**HYDE PARK CITY
CITY HALL WELL HOUSE AND TRANSMISSION LINE
ADDENDUM #2**

FEBRUARY 20, 2025

This Addendum #2 covers the following items:

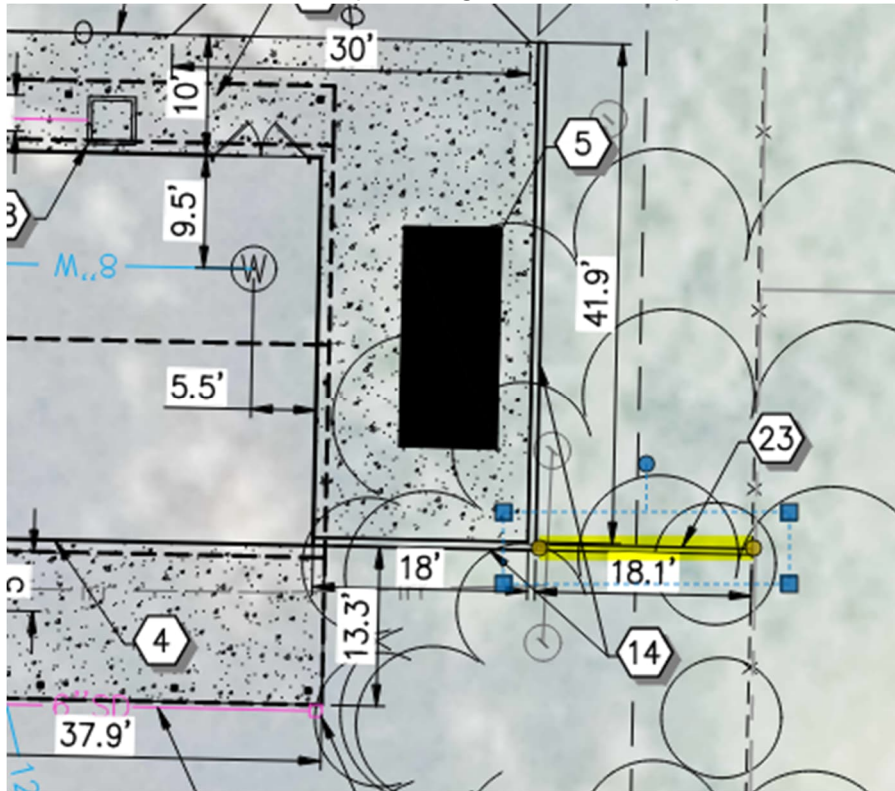
Q: What bid item should the 6" concrete mow curb be included in? Note 23 on sheet SP1 calls for this, but it is unclear where it should be placed and how much. Please clarify.

A: Bid Item #44. Between the CMU wall and fence line to separate the grass from the gravel. The screenshot below for clarity is from SP1. There is an erroneous 23 construction note north of here, please ignore. Mow strip shall be 6" wide and 6" tall.

There is an additional "mow curb" under the fence identified by construction note 3 on SP1. This is to be paid for as part of the fence bid item #19
